BULLETINS

POSTED SET

# HAYDEN ELEMENTARY SCHOOL

## WESTMINSTER SCHOOL DISTRICT

SHEET M-2.1 - MECHANICAL FLOOR PLAN - BLDGS. 'B' & 'C'

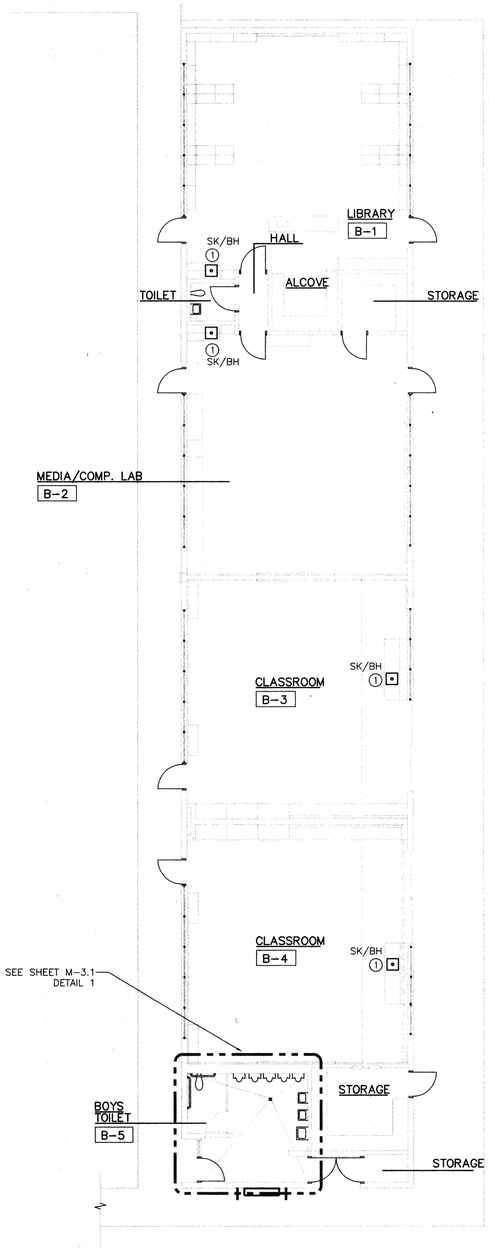
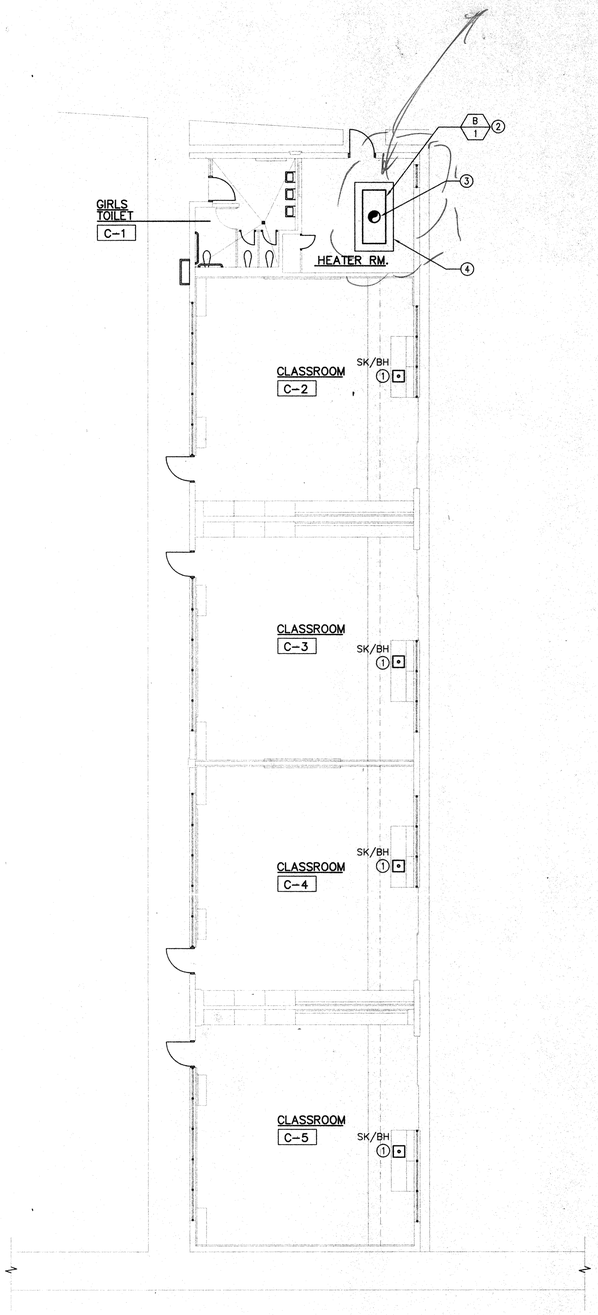
23. At Bldg. 'C' Heater Room, DELETE all work associated with boiler and boiler piping replacement. Per Add #2
